# Access Compliance Report

## Public Rights-of-Way

### (Curb Ramps)

Intersection ID: 21549	Main Street: S_TRYON_ST	Cross Street: SANDY_PORTER_RD	Location: SE
ADA ID: 9B522106166C	Ramp Type: Perp	Initial Pass/Fail: Fail	Overall Compliance: No
Severity Score: 13.75			
Codes/Mitigation Info/Possible Solution		Field Measurements/Component Compliance

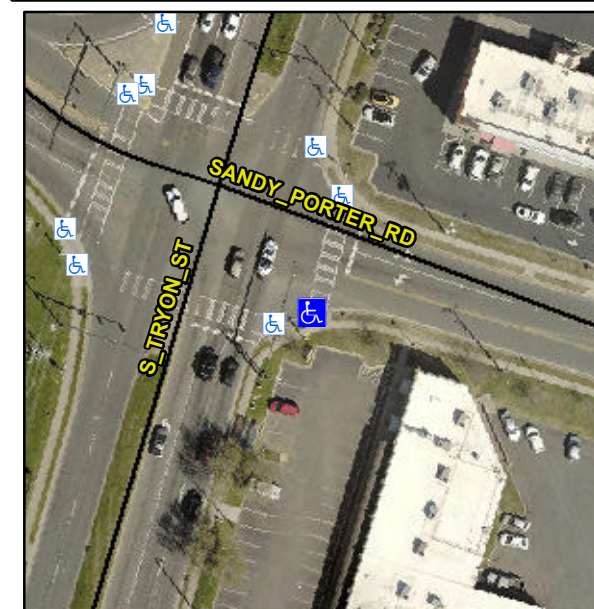
Compliance	Description	Data	Compliance	Description	Data
N/A	Ramp Length (in)	47.0	No	Ramp Slope (%)	8.8
Yes	Ramp Width (in)	48.0	Yes	Ramp XSlope (%)	2.1
N/A	Flare Type LT	N/A	N/A	Flare Type RT	N/A
N/A	Flare Slope LT (%)	N/A	N/A	Flare Slope RT (%)	N/A
N/A	Flare Traversable LT?	N/A	N/A	Flare Traversable RT?	N/A
N/A	Landing Length (in)	N/A	N/A	DWS Provided?	N/A
N/A	Landing Width (in)	N/A	N/A	DWS Contrast?	N/A
N/A	Landing Slope (%)	N/A	N/A	DWS Length (in)	N/A
N/A	Landing X Slope (%)	N/A	N/A	DWS Full Width?	N/A
N/A	Landing Curb? (Y/N)	N/A	N/A	DWS Offset (in)	N/A
N/A	Shared Landing?	N/A			
N/A	Gutter Ponding?	N/A	N/A	Gutter Slope (%)	N/A
N/A	Gutter Lip Ht (in)	N/A	N/A	Gutter X Slope (%)	N/A
N/A	Painted X Walk1?	Yes	N/A	Painted X Walk2?	N/A
	X Walk 1 Direction	To N		X Walk 2 Direction	N/A
N/A	X Walk 1 Width (in)	110.0	N/A	X Walk 2 Width (in)	N/A
	X Walk 1 Slope (%)	0.5		X Walk 2 Slope (%)	N/A
	X Walk 1 X Slope (%)	2.5		X Walk 2 X Slope (%)	N/A

N/A	Ramp inside XWalk1?	Yes	N/A	Ramp inside XWalk2?	N/A
	Road Slope (%)	N/A	N/A	Clear Space?	N/A
	Road X Slope (%)	N/A	N/A	Clear Space to XWalk (in)	N/A
N/A	Any Obstructions?	N/A	N/A	Storm Grate/Utility Hazard?	N/A
	Obstruction Type			Storm Grate/Utility Type	
		N/A			N/A
			Yes	Surface Condition? (G/P)	Good

**Remove & Replace Entire Ramp.**

**R304.2.2**
